## Minnesota Pollution Control Agency

Enclosed for your review is the Minnesota Pollution Control Agency's (MPCA) proposed revisions to the General Mills Remedial Action Plan submitted to the MPCA on April 11, 1984. I anticipate that our meeting on May 7, 1984 will focus on General Mills' comments regarding MPCA's proposed Consent Order mailed to you on March 23, 1984 and on MPCA's proposed revisions to the General Mills Remedial Action Plan.

EXHIBIT A  
REMEDIAL ACTION PLAN

ATTACHMENT <sup>A</sup><sub>B</sub>  
GLACIAL DRIFT  
PUMPOUT SYSTEM

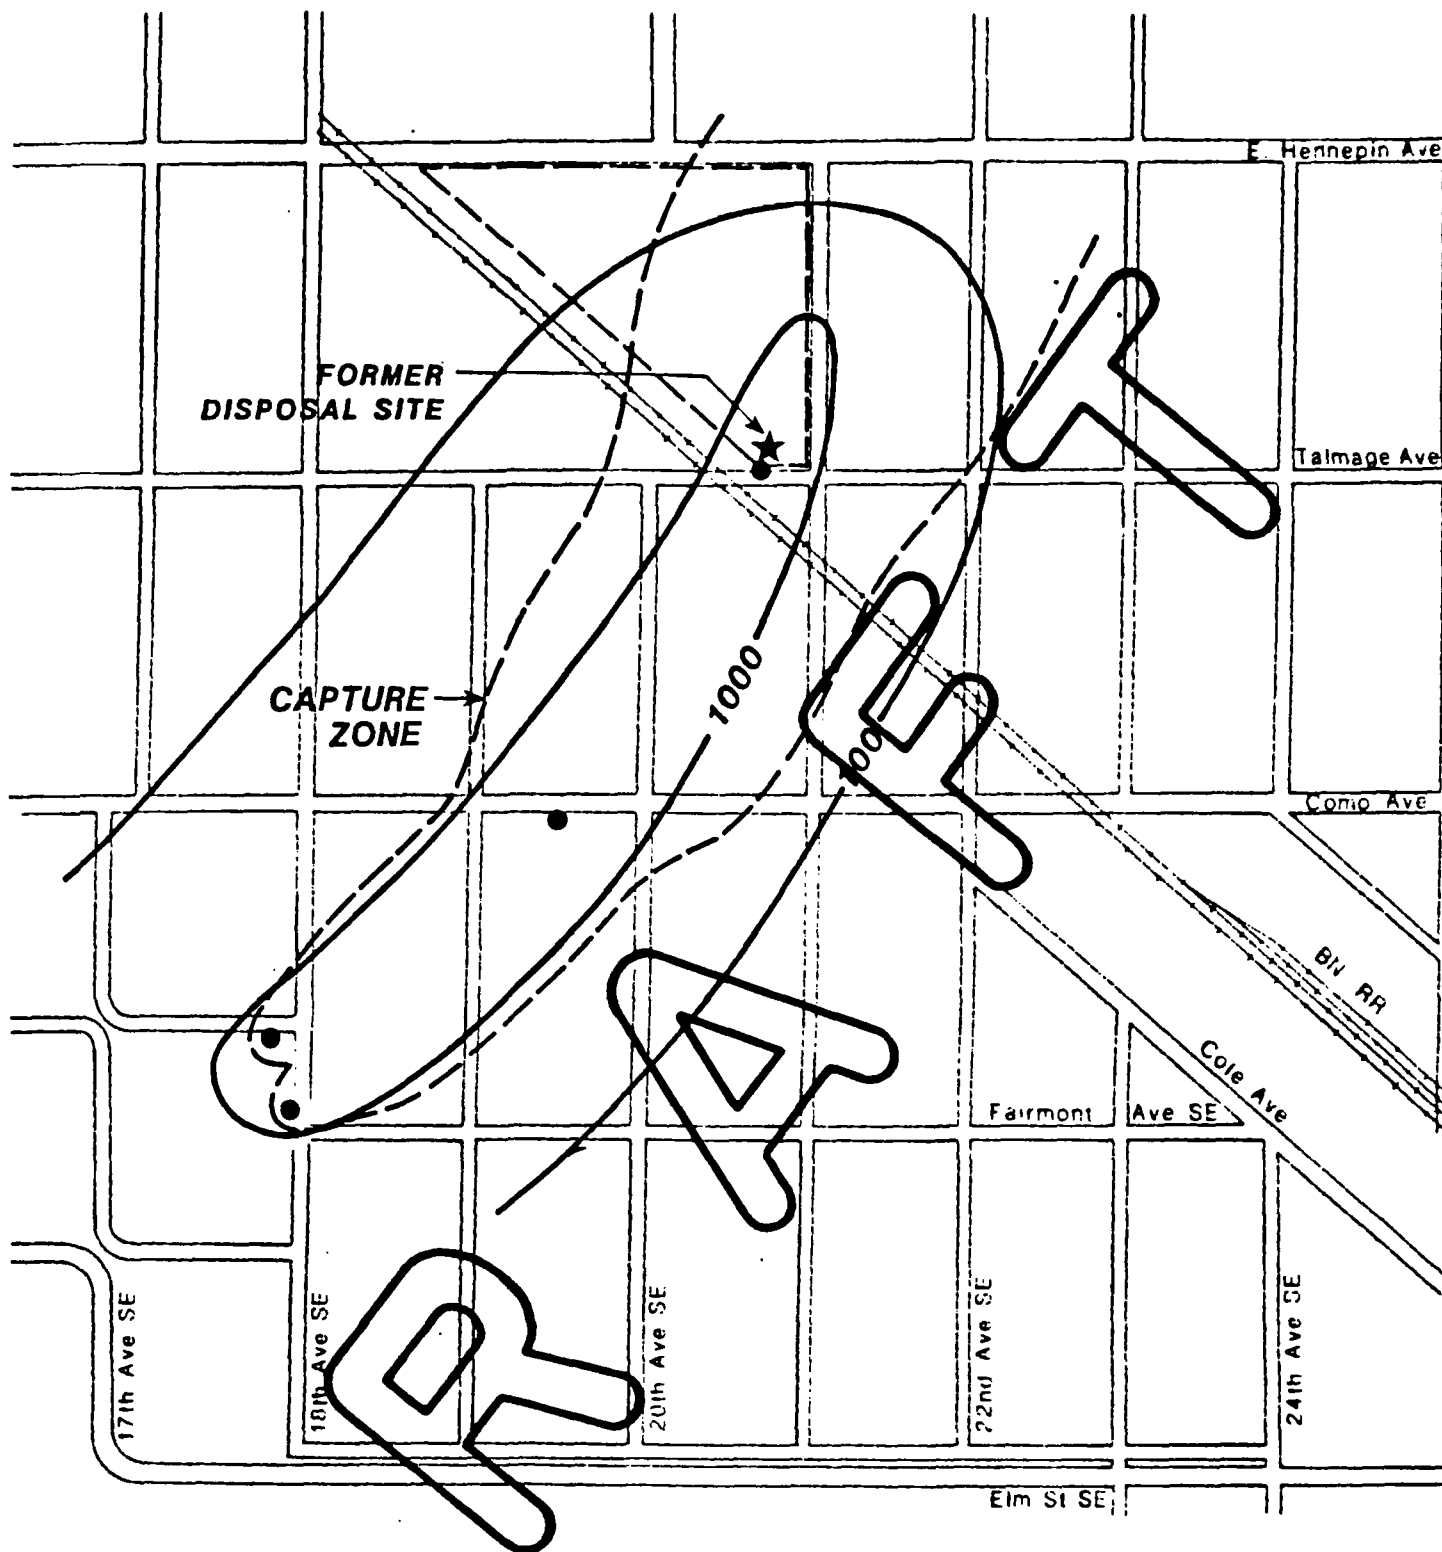
\* Need to modify to show TCE contours and new estimated capture zone

ATTACHMENT **B** X  
CARIMONA  
PUMPOUT SYSTEM

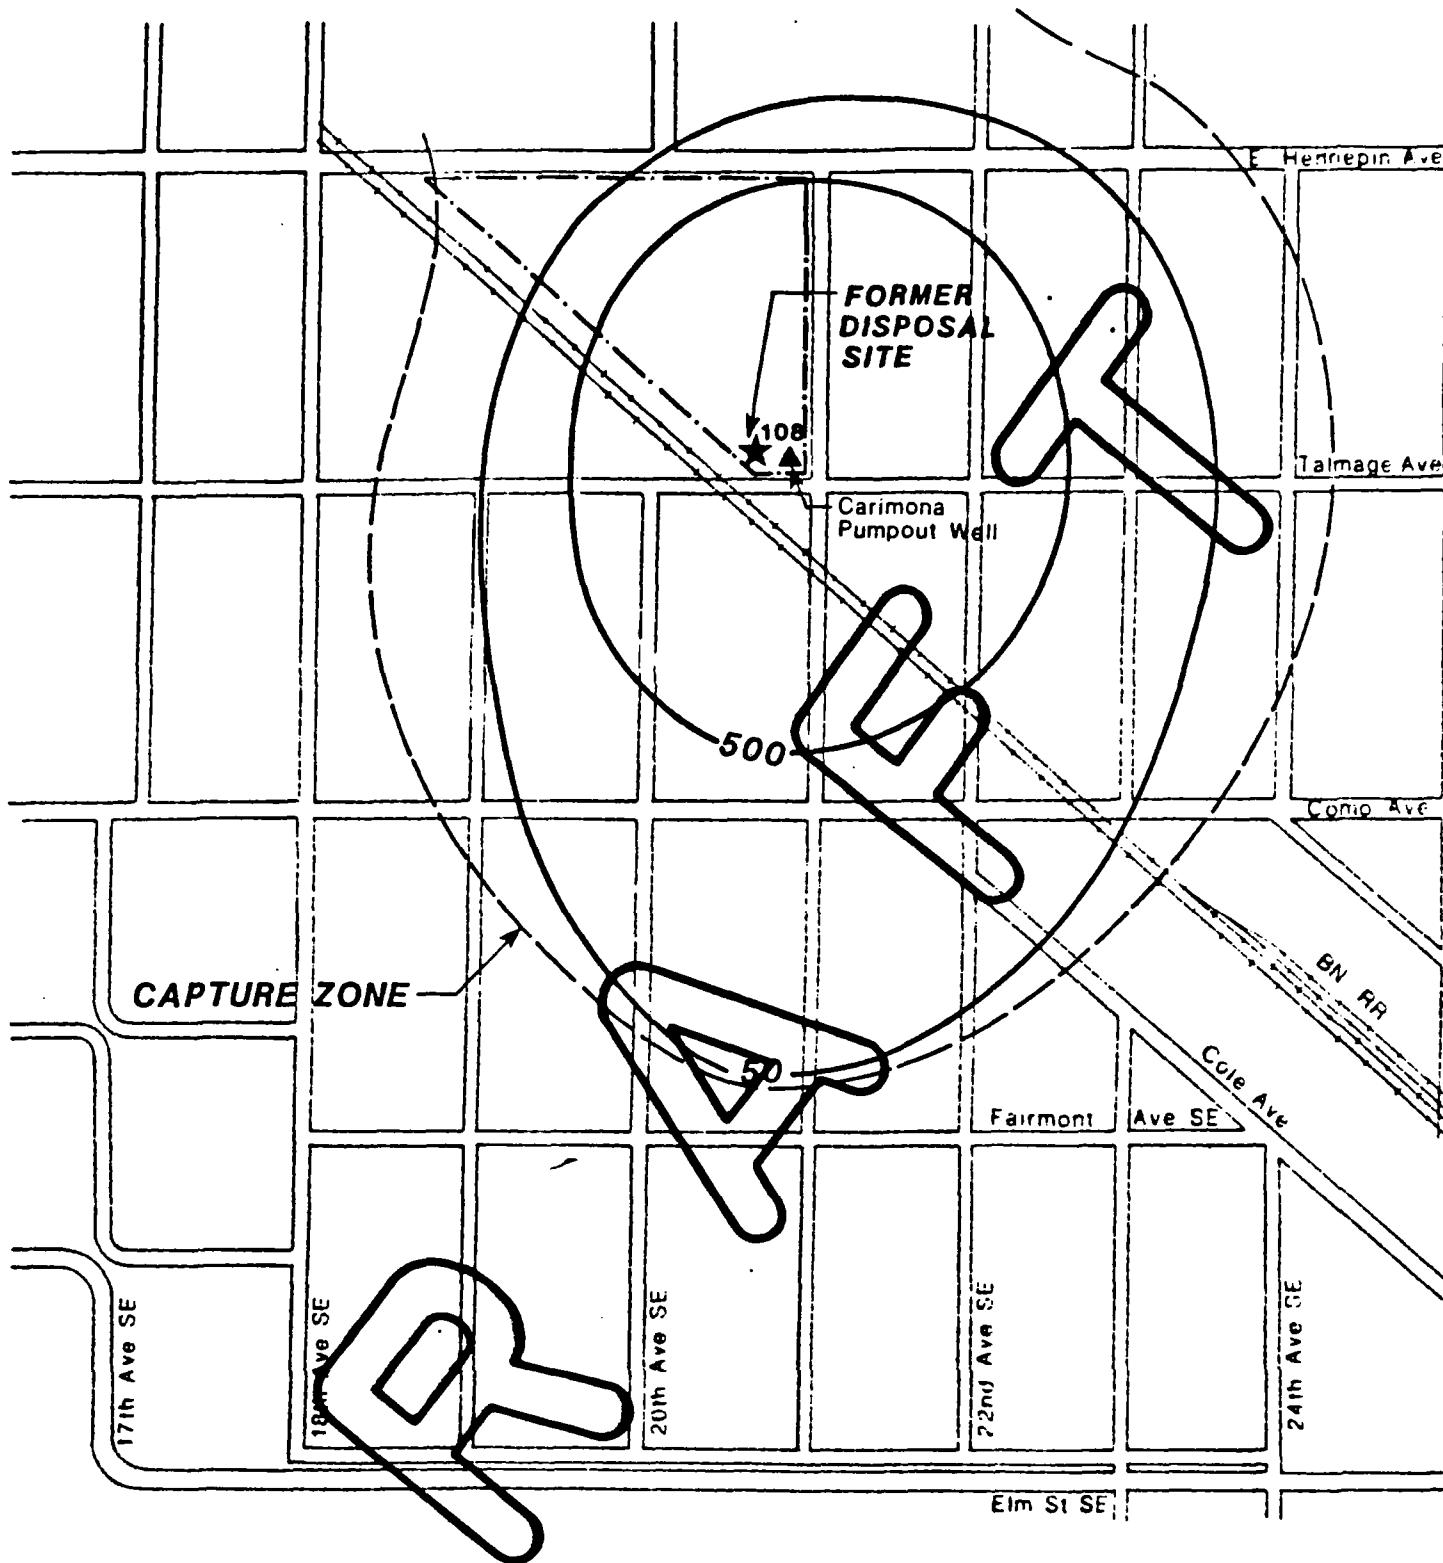
\* Need to modify to show TCE contours and estimated capture zone

# ATTACHMENT <sup>P</sup><sub>F</sub> CARIMONA & MAGNOLIA WATER LEVEL MONITORING WELLS

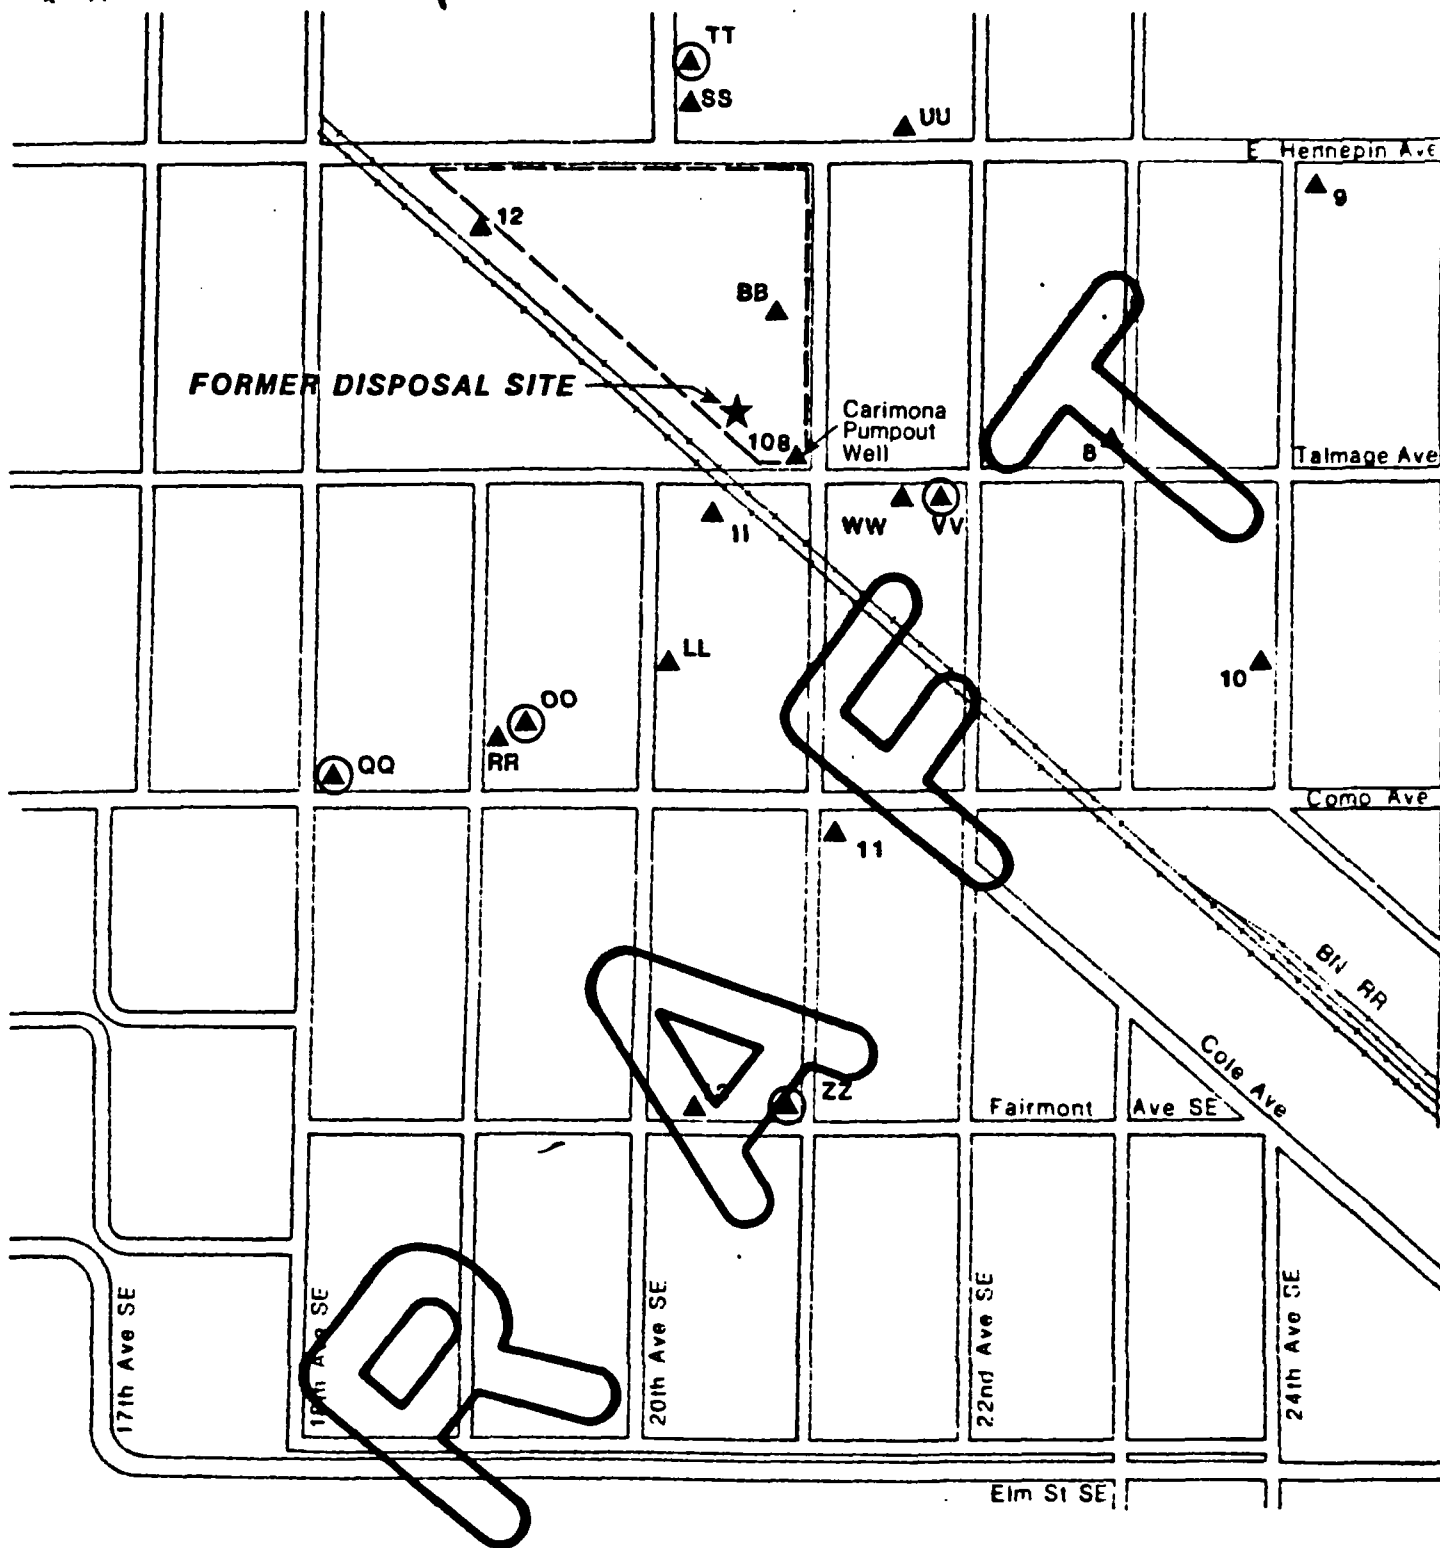
\* Add G6 to the map

D  
ATTACHMENT F (Cont.)  
GLACIAL DRIFT WATER  
LEVEL MONITORING WELLS

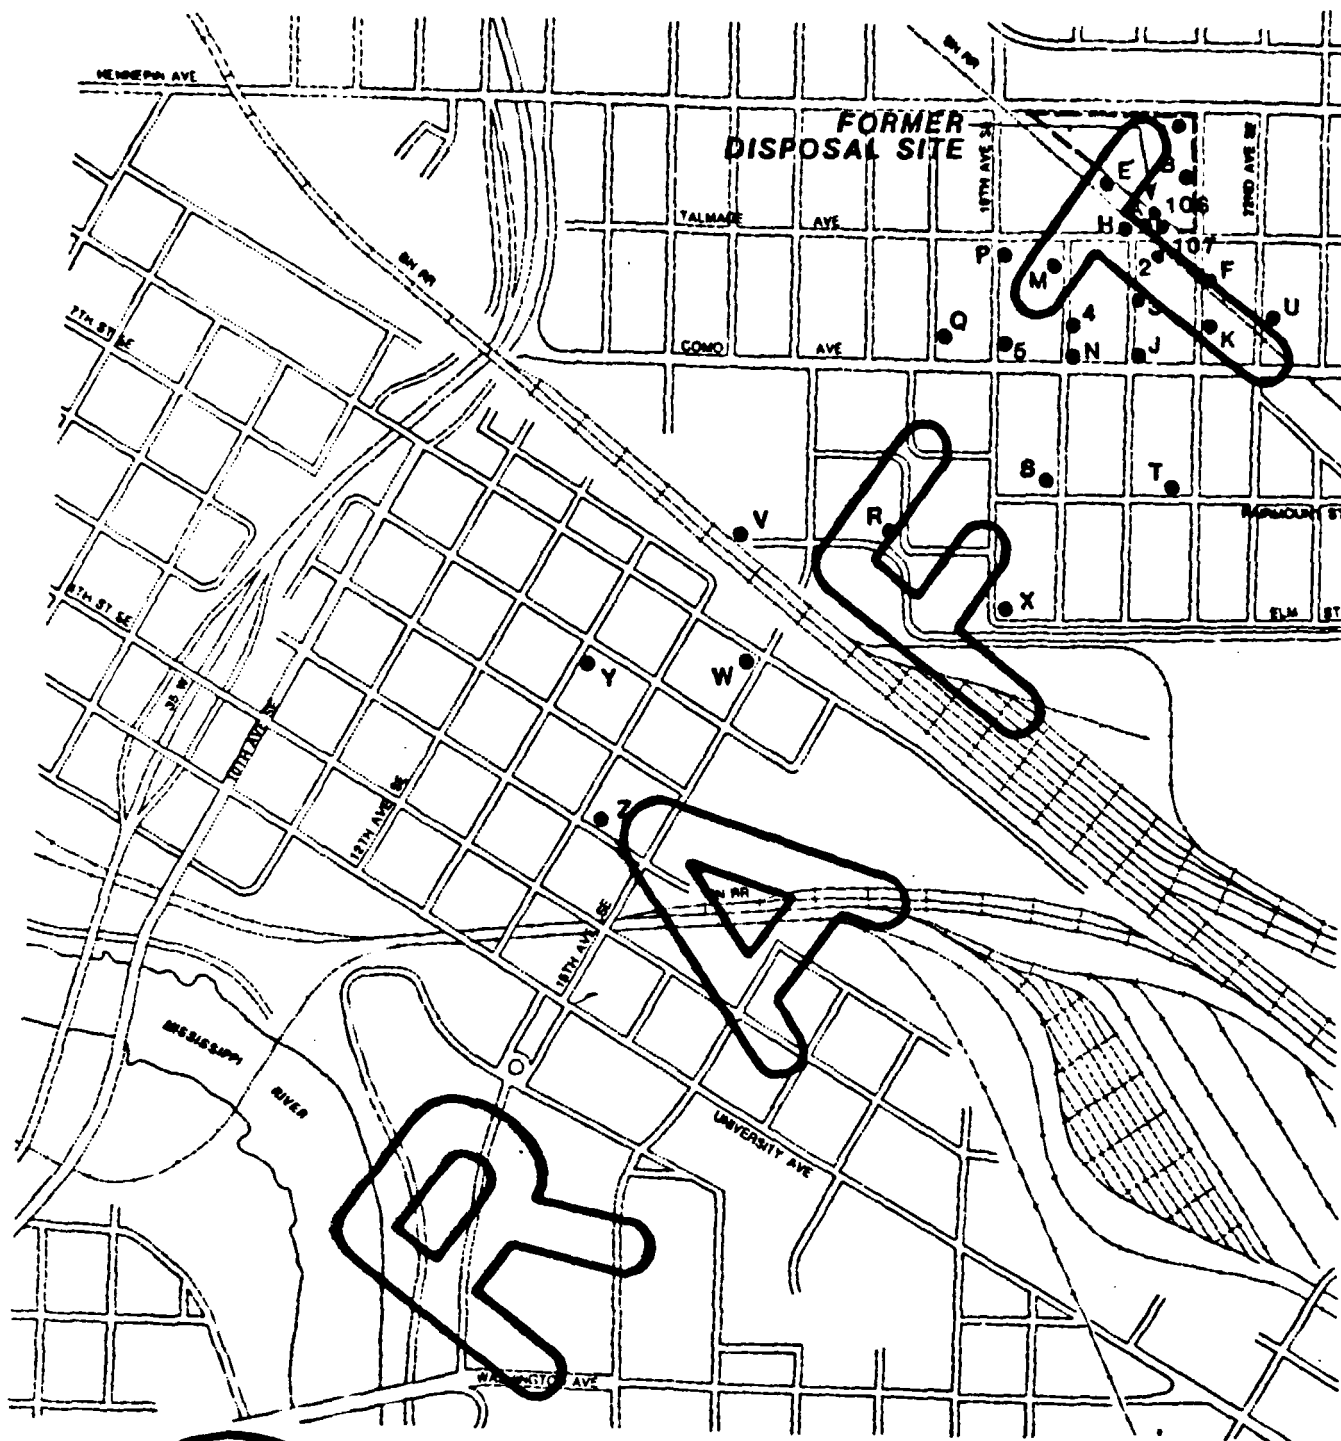
\* include the glacial drift pump-out wells to the map.

ATTACHMENT <sup>E</sup>  
 CARIMONA & MAGNOLIA  
 SAMPLING WELLS

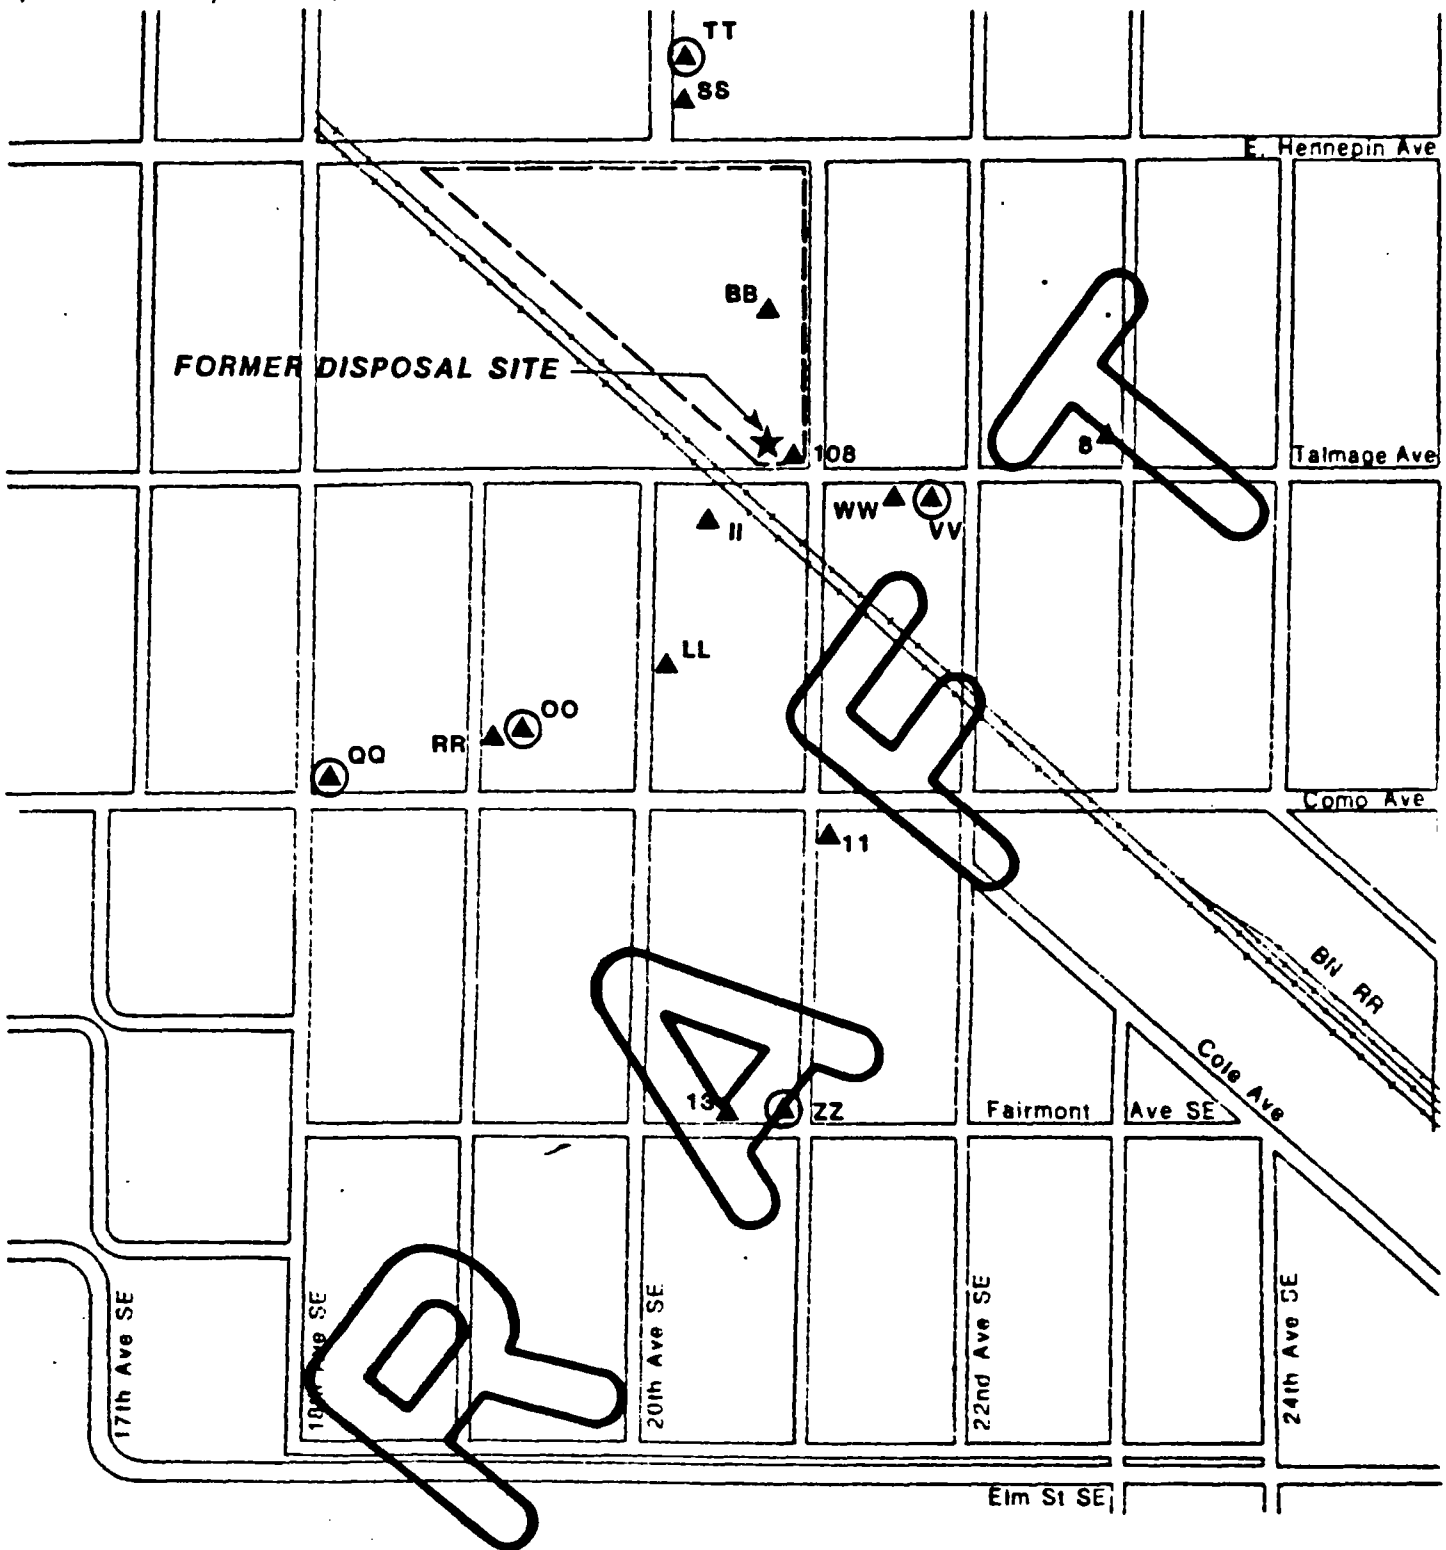
\* Add GG, UU, 9, 10 and 12 to the map
